Access Compliance Report Public Rights-of-Way (Curb Ramps)

Intersection ID: 10024061 Main Street: CORPORATE_CENTER_DR Cross Street: N/A Location: SE

ADA ID: 77BB8D2B32C9 Ramp Type: Perp Initial Pass/Fail: Fail Overall Compliance: No Severity Score: 46.25

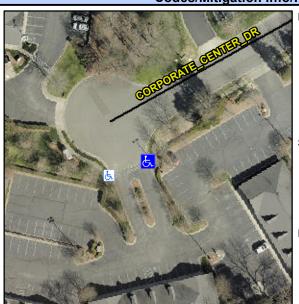
Not Found, R304.5.1, R304.2.2, R304.5.3

Field Measurements/Component Compliance					
Comp	liance Description	Data	Comp	liance Description	Data
N/A	Ramp Length (in)	93.0	No	Ramp Slope (%)	9.4
No	Ramp Width (in)	45.0	No	Ramp XSlope (%)	9.1
N/A	Flare Type LT	N/A	N/A	Flare Type RT	N/A
N/A	Flare Slope LT (%)	N/A	N/A	Flare Slope RT (%)	N/A
N/A	Flare Traversable LT?	N/A	N/A	Flare Traversable RT?	N/A
N/A	Landing Length (in)	N/A	N/A	DWS Provided?	N/A
N/A	Landing Width (in)	N/A	N/A	DWS Contrast?	N/A
N/A	Landing Slope (%)	N/A	N/A	DWS Length (in)	N/A
N/A	Landing X Slope (%)	N/A	N/A	DWS Full Width?	N/A
N/A	Landing Curb? (Y/N)	N/A	N/A	DWS Offset (in)	N/A
N/A	Shared Landing?	N/A			
N/A	Gutter Ponding?	N/A	N/A	Gutter Slope (%)	N/A
N/A	Gutter Lip Ht (in)	N/A	N/A	Gutter X Slope (%)	N/A
N/A	Painted X Walk1?	Yes	N/A	Painted X Walk2?	N/A
	X Walk 1 Direction	To W		X Walk 2 Direction	N/A
N/A	X Walk 1 Width (in)	56.0	N/A	X Walk 2 Width (in)	N/A
	X Walk 1 Slope (%)	0.6		X Walk 2 Slope (%)	N/A

Remove & Replace Entire Ramp.
